ADDENDUM NO. 3 TO PROJECT NO. 44559

CONSTRUCTION WORK, HVAC WORK, PLUMBING WORK, AND ELECTRICAL WORK
PROVIDE STATE POLICE FORENSIC IDENTIFICATION UNIT BUILDING,
HEADQUARTERS ADDITION AND COLD STORAGE BUILDING
TROOP E HEADQUARTERS
1569 ROCHESTER ROAD
CANANDAIGUA, NEW YORK

February 11, 2016

1 PARTIAL FIRST FLOOR REMOVALS PLAN
 1/8" = 1'-0"

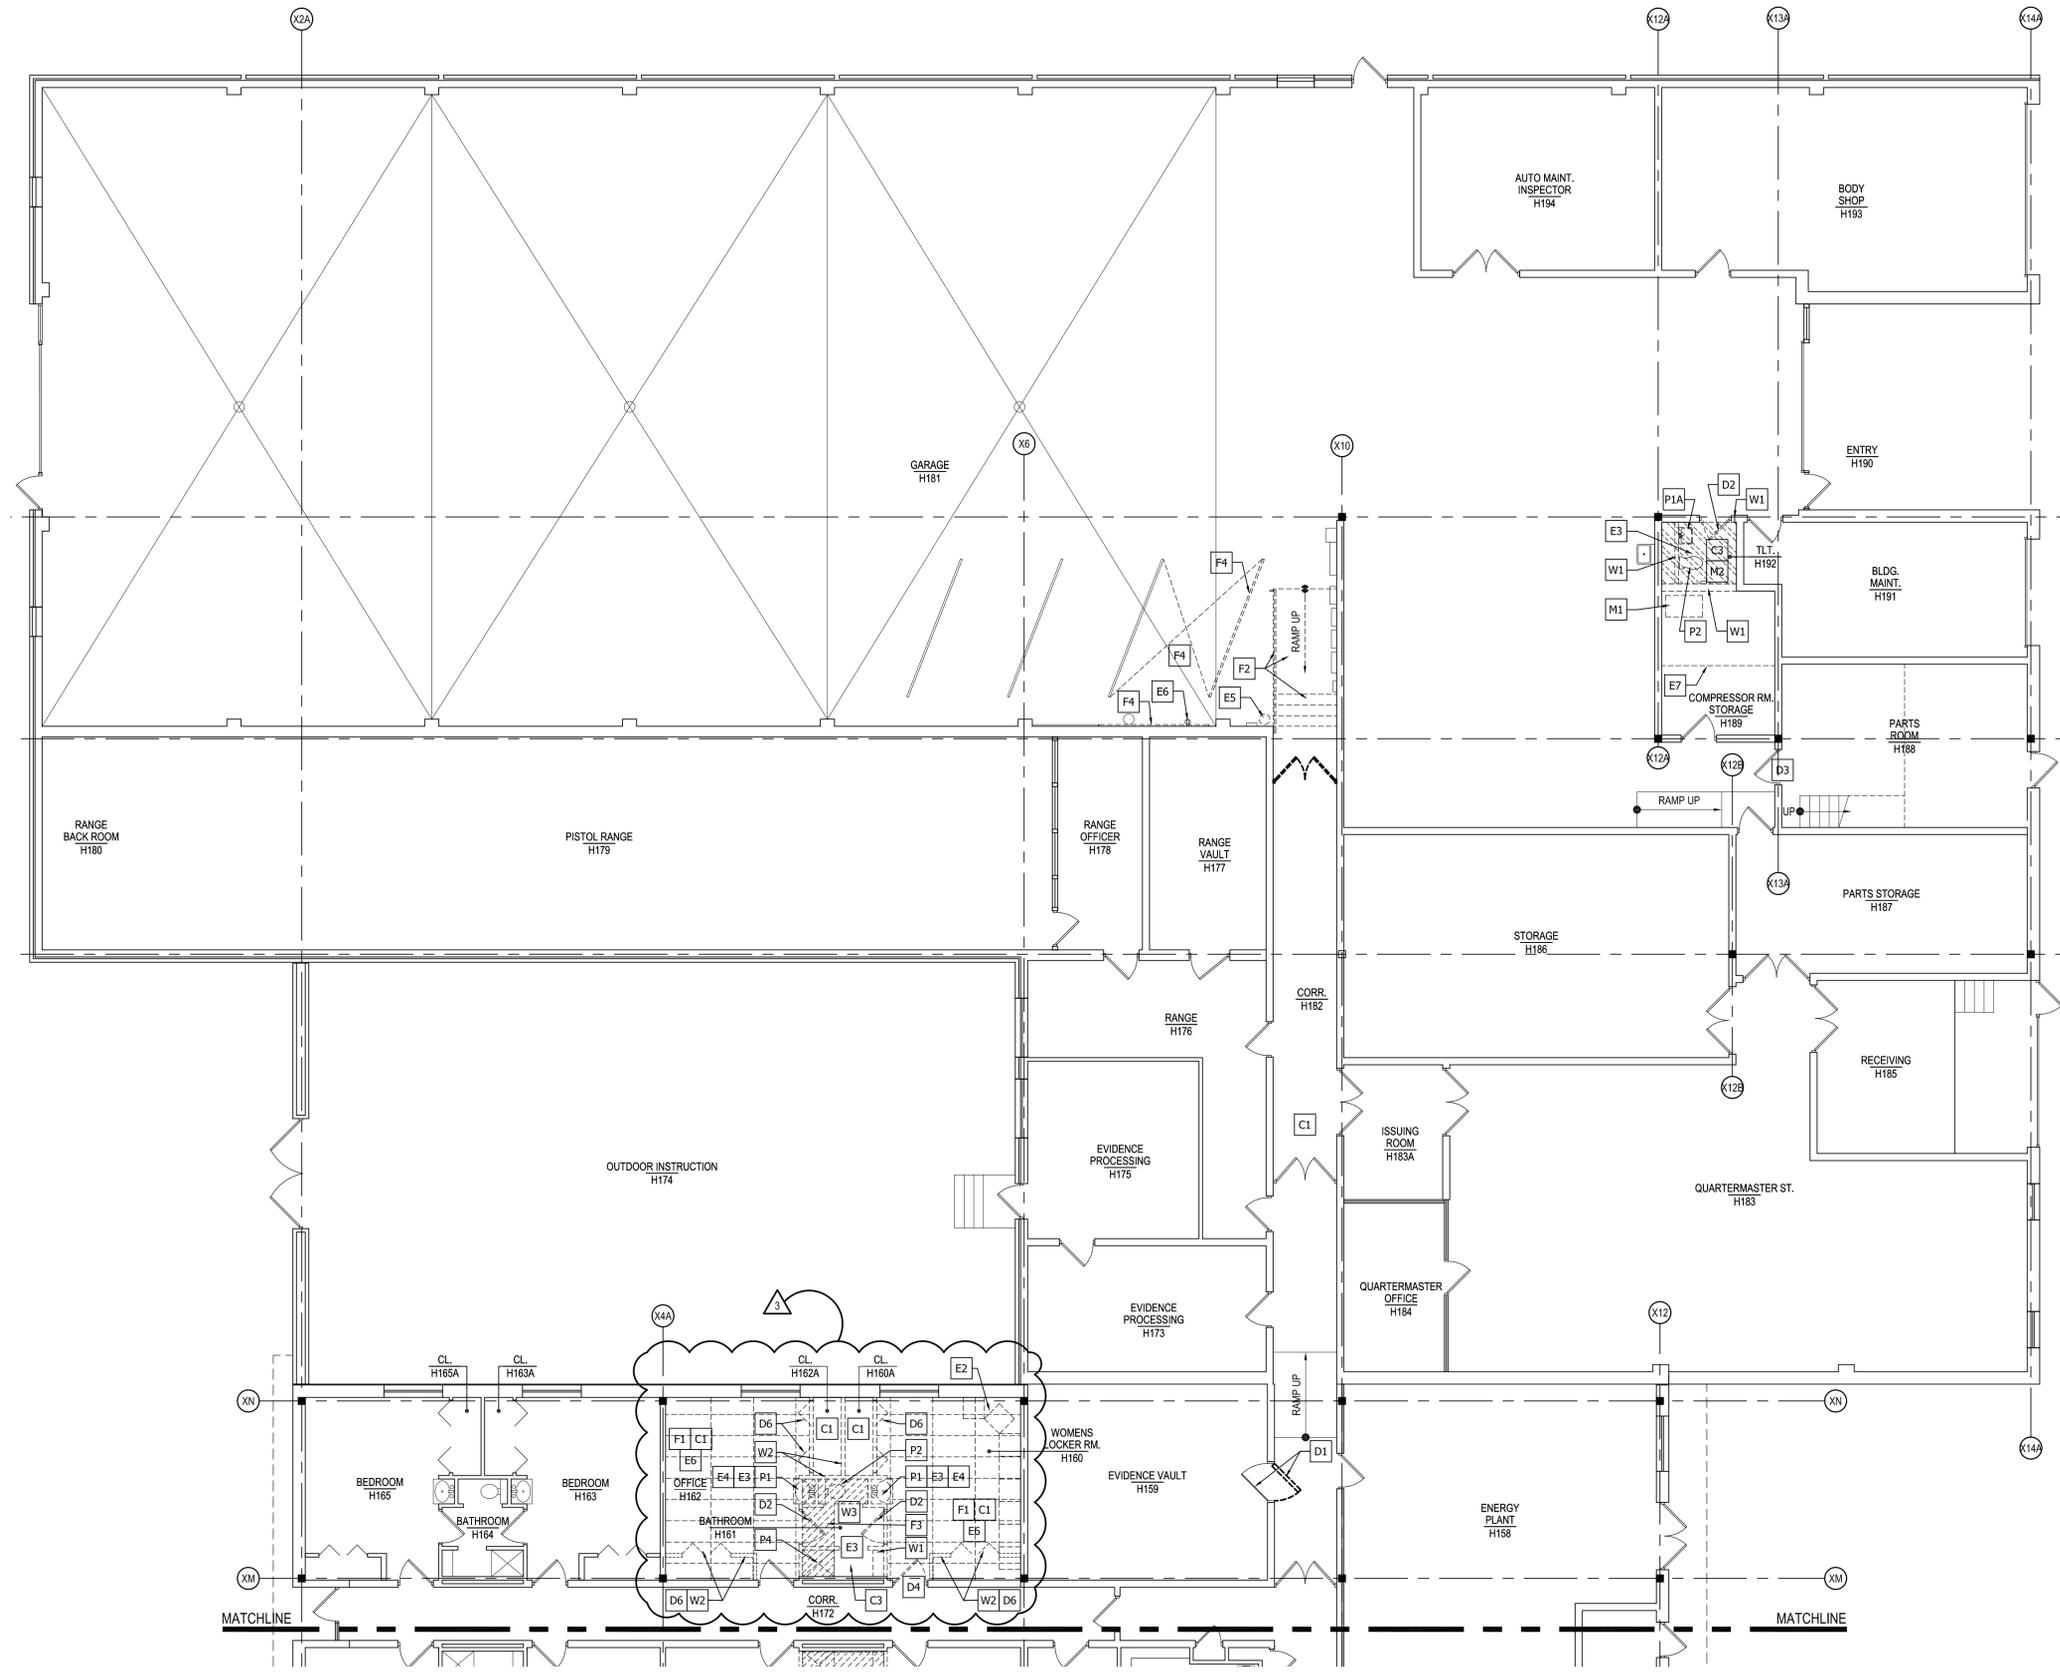
16. Drawing A-103 H Partial First Floor Removal Plan
 - a. ADD note P4 "Existing shower and associated drain, accessories and piping to be removed and capped by P-Contract. Coordinate with MEP contracts.

- b. ADD note "Remove existing ceramic tile floor finish at toilet room alcoves H141 & H143 and prepare floor to accept carpet tile to be provided by Facility.
